UNITED STATES ENVIRONMENTAL PROTECTION AGENCY
REGION IX
75 Hawthorne Street
San Francisco, CA

Thank you for providing for review the *Draft Work Plan, Radiological Survey and Sampling,* Former Hunters Point Naval Shipyard, San Francisco, California ("Work Plan"), February 2018. The U.S. Environmental Protection Agency (EPA) reviewed this report in detail with a technical team including national experts in health physics, geology, and statistics.

EPA Review of the Draft Work Plan Radiological Survey and Sampling
Former Hunters Point Naval Shipyard,
San Francisco, California, February 2018

STATISTICAL REVIEW OF UNITED STATES NAVY PROPOSED WORK PLAN FOR RADIOLOGICAL SURVEY AND SAMPLING, HUNTERS POINT NAVAL SHIPYARD SITE (HPNS)

Figure 1. Distribution of Ra-226 Off-Site Laboratory Measurements in picocuries per gram (pCi/g) in Background Reference Areas

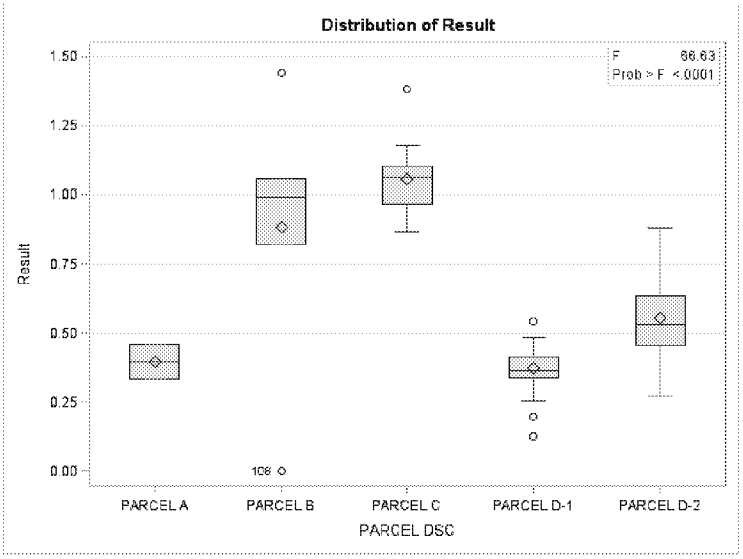
Reviewer Comments: In order to meet MARSSIM and NRC criteria, sample sizes for background reference areas should be computed per independent interval, surface soils and subsurface soils, not across both. Additionally, it is clear from historical data provided by the Navy and collected at the background reference areas in Parcels A, B, C, D-1, and D-2, that variability is not consistent across the five areas for off-site laboratory Ra-226 measurements (Figure 1).

Recommendations: Given the differences in variability and mean/median concentrations for Ra-226 as demonstrated in Figure 1, it is recommended that background reference area sample data should not be combined across the five areas, but rather background reference areas should be established per Parcel with sample sizes computed based on the variability within each background reference area per independent interval (surface soils and subsurface soils).

Sample sizes should be justified with detailed statistical analyses and explanations of how inputs to the computations were derived, including specifics of how estimates of variability were obtained (e.g., what data was included in the calculation, how and where the data was collected, what assumptions were made). If measurements from multiple background reference areas will be combined, the results of a comparative analysis such as an Analysis of Variance (ANOVA) or non-parametric equivalent (Kruskal-Wallis Test) must be documented to support combining the areas. These comparative tests will establish if there is a statistically significant difference between Ra-226 and Cs-137 in the background reference areas at a specified confidence-level.
